BCA ASSESSMENT REPORT

Wollongong Private Hospital SSDA – 360-364 Crown Street, Wollongong NSW 2500

Project number: 253348
Revision: 1.0
Date: 2 December 2025

Figure 7 - External Openings Between Fire Compartments Level 4

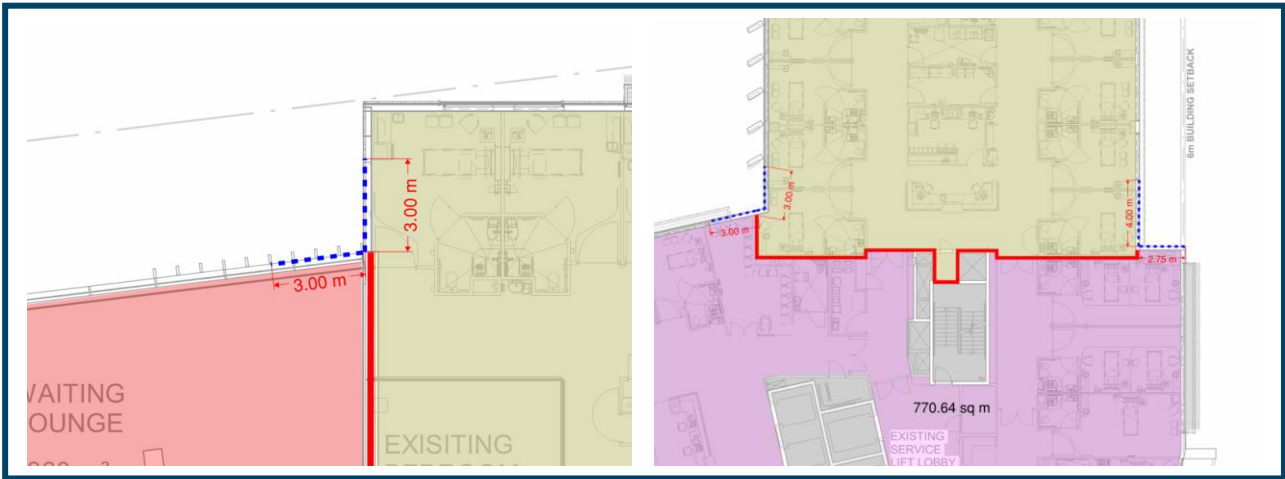
As nominated with blue lines in Figure 7 below, external walls are required to achieve an FRL not less than 60/60/60 and glazed openings within the external walls are required to be protected as per BCA Clause C4D5, where windows are provided with internal or external wall-wetting sprinklers or windows achieve a - /60/- FRL and windows are automatic closing or permanently fixed in the closed position. Where it is not possible to provide wall-wetting sprinkler protection, these unprotected openings between fire compartments are to be addressed under a fire engineered performance solution.

- + Level 2 – Existing central Mechanical Plant Room & existing ward (maternity ward).
- + Level 2 – Existing central Mechanical Plant Room & new 33m² plant room.
- + Level 3 – Existing Inpatient Ward 2 and existing Inpatient Ward 3 (Eastern and Western sides).
- + Level 3 – Existing Inpatient Ward 2 and proposed Waiting Lounge.
- + Level 4 – Existing Inpatient Ward 4 and existing Inpatient Ward 5 (Eastern and Western sides).
- + Level 4 – Existing Inpatient Ward 4 and proposed Waiting Lounge.
- + Level 5 – Existing central waiting area (RM1654) and existing plant room (RM1753).

- + Level 5 – Existing Day Oncology and existing Consulting Suite 501.
- + Level 5 – Existing Cath Lab and proposed Waiting Lounge.

The existing building plans provided indicate that fire-rated walls are provided in some instances and not in others. As the existing Fire Engineering Reports do not indicate that the openings between two existing areas have been addressed under performance solutions, it is assumed that drencher protection has been provided. Confirmation of the provision of drencher protection to new and existing openings as identified above is to be provided as the design develops.

Figure 8 - External Separation Between Fire Compartments (Ground Floor)

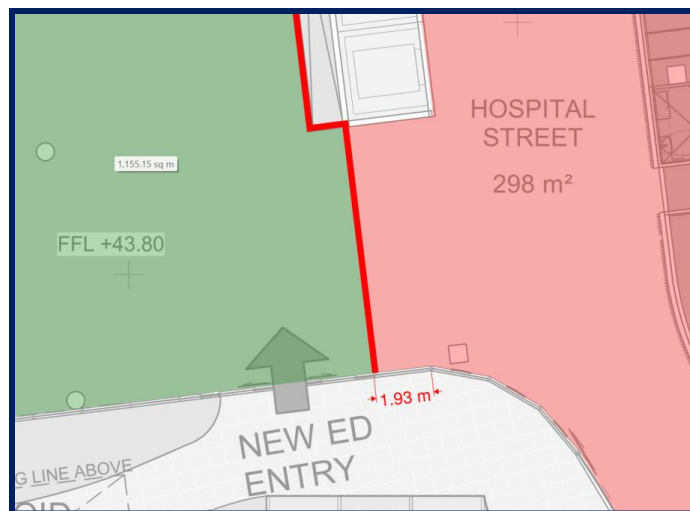
11.	It is noted that the external separation between fire compartments on the Ground Floor between the new Hospital Street and the new Emergency Department is not required if the 180° separation is achieved for more than 2.0m. The current plans indicate that the external glazed wall of the Hospital Street curve within 2.0m of the external walls of the Emergency Department (refer to Figure 8 below) which will require the external walls of both fire compartments to achieve a 60/60/60 FRL or be drencher protected for 2m on either side of the dividing wall. It is recommended that the	C4D4

It is noted that the external separation between fire compartments on the Ground Floor between the new Hospital Street and the new Emergency Department is not required if the 180° separation is achieved for more than 2.0m. The current plans indicate that the external glazed wall of the Hospital Street curve within 2.0m of the external walls of the Emergency Department (refer to Figure 8 below) which will require the external walls of both fire compartments to achieve a 60/60/60 FRL or be drencher protected for 2m on either side of the dividing wall. It is recommended that the external wall design is amended to ensure that the proposed curve does not commence within this distance.

Item	Description	BCA Provision
	external wall design is amended to ensure that the proposed curve does not commence within this distance.	
12.	<p>The proposed discharge arrangement for the eastern fire-isolated stair serving the above-ground storeys of the building is unclear and as such, compliance is unable to be confirmed. Further review of the stair discharge arrangements will be undertaken as the design develops.</p> <p>Furthermore, it is noted that the Western stair core will discharge into a fire-isolated passage on the Lower Ground Floor however, the plans do not indicate how the separation of the stair rising from the basement storeys and the stair descending from the above-ground storeys will be achieved. Further review is to be undertaken as the design develops.</p>	D2D12, D2D15 & D3D5
